ARAPAHOE COUNTY  
COLORADO'S FIRST

**RE:** **STANDARD DETAIL SP-16B SUMMARY OF KEY CHANGES**

SIDEWALK CHASE  
IF PERMITTED BY VARIANCE

Drawing Number:  
SP. 16b

SECTION A-A  
FLOW FROM GUTTER

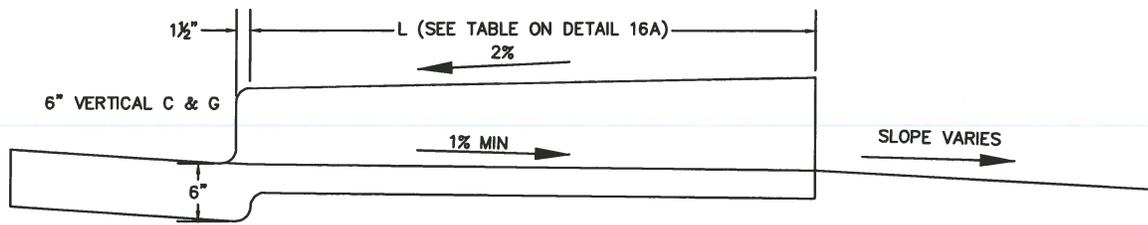
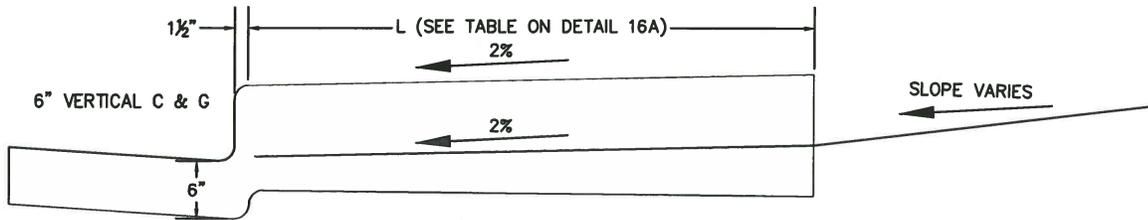
- The overall width formula for the Section B-B was incorrect. The proposed solution is to show the outside width (left side) as 6”.
- The flow directions for the two cases of Section A-A were reversed. The proposed corrections are shown.
- Three notes that reference “fabrication shop drawings” are changes to read “fabrication shop drawings approved by the Engineer”. The table showing WO width of opening and TP thickness of plate is relocated in the detail to allow space for these notation clarifications.
- The 6” and 8” dimensions from top of curb to flowline for the two cases of Section A-A are omitted as being unnecessary and in some cases incorrect.
